## PRODUCT SAFETY WARNING AND RECALL NOTICE

## REMINGTON MODEL 700TM AND MODEL SEVENTM RIFLES

<u>PRODUCTS</u>: Remington Arms Company, LLC ("Remington") is voluntarily recalling Remington Model 700<sup>TM</sup> and Model Seven<sup>TM</sup> rifles with X-Mark Pro® ("XMP®") triggers, manufactured from May 1, 2006 to April 9, 2014.

## GRAPHIC A: HOW TO FIND YOUR SERIAL NUMBER

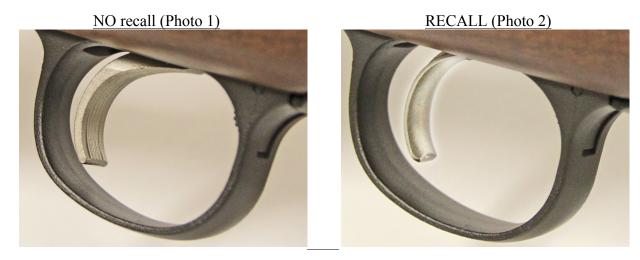
- I. Find the rifle's serial number where the barrel meets the receiver. SEE GRAPHIC A
  - a. For a right-handed rifle, the serial number is located on a user's left.
  - b. For a left-handed rifle, the serial number is located on a user's right.
